SUBJECT: REQUEST FOR ADDITIONAL INFORMATION LETTER NO. 016 RELATED TO SRP SECTION 2.3.1 FOR THE LEVY COUNTY NUCLEAR PLANT, UNITS 1 and 2 COMBINED LICENSE APPLICATION

Request for Additional Information
Levy County, Units 1 and 2
Progress Energy Florida, Inc.
Docket No. 52-029 and 52-030
SRP Section: 02.03.01 - Regional Climatology
Application Section: General Climate

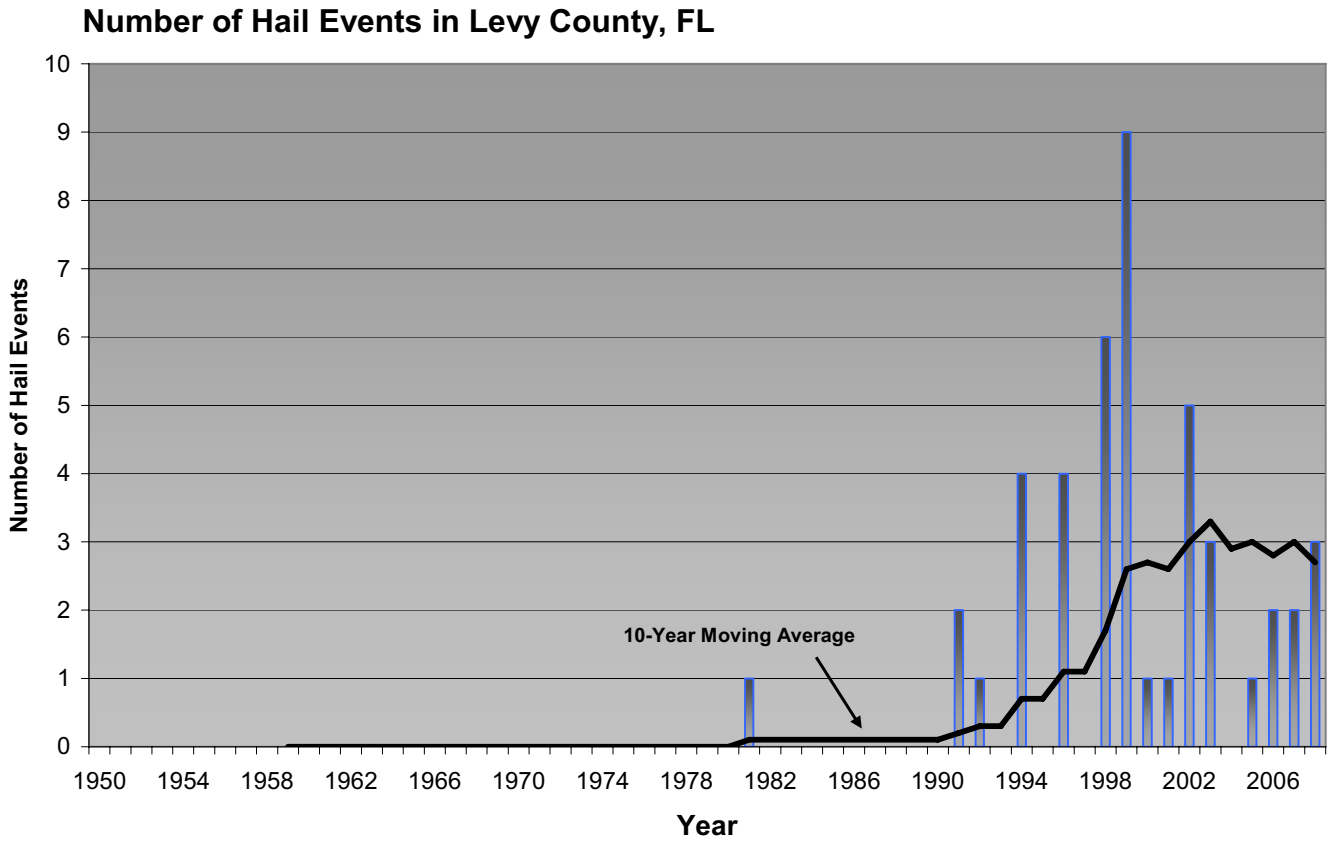
The Staff notes that in the NCDC Storm Events Database many severe weather reports are often incomplete or missing for older periods of record. The following graph shows the annual number of hail events that have occurred in Levy County, FL. Note the increase in the number of reported events during the more recent years in the attached graph.

Please revise FSAR Section 2.3.1.2.1 to account for this data deficiency, or provide an explanation why the data presented in Section 2.3.1.2.1 is accurate.
